SUBJECT: REQUEST FOR ADDITIONAL INFORMATION - ROUND TWO QUESTIONS
AND STAFF POSITIONS

GIBBS AND HILL STANDARD BALANCE OF PLANT

GIBBSSAR

SSAR Second Request for Information

FIG 1. PROPOSED DUCTILITY RATIO FOR BEAM-COLUMNS

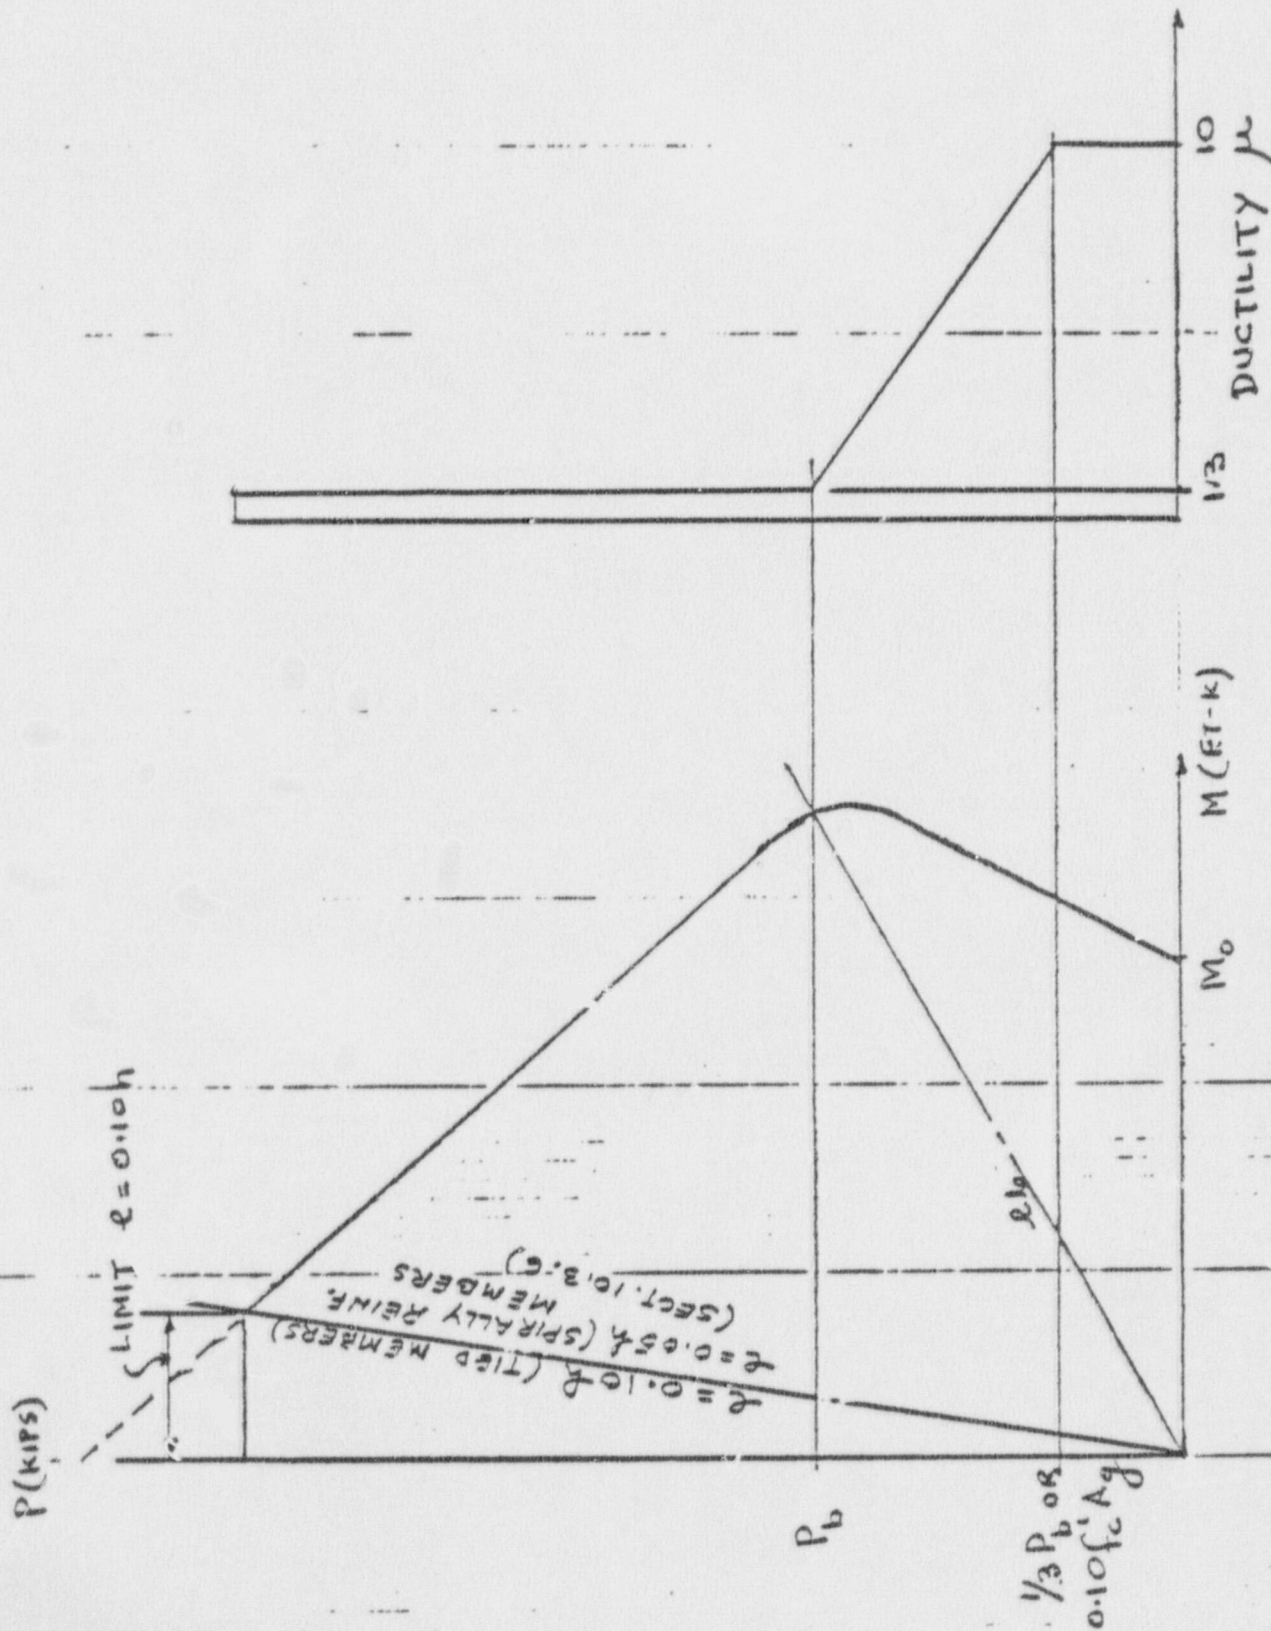
1.3 For beam-columns, walls, and slabs carrying axial compression loads and subject to impulsive or impactive loads producing flexure, the permissible ductility ratio in flexure should be as follows:

- (a) When compression controls the design, as defined by an interaction diagram, the permissible ductility ratio shall be 1.3.
- (b) When the compression load does not exceed $0.1fc' A_g$ or one-third of that which would produce balanced conditions, whichever, is smaller, the permissible ductility ratio can be as given in Section 1.1.
- (c) The permissible ductility ratio shall vary linearly from 1.3 to that given in Section 1.1 for conditions between those specified in (a) and (b). (See Fig. 1.)
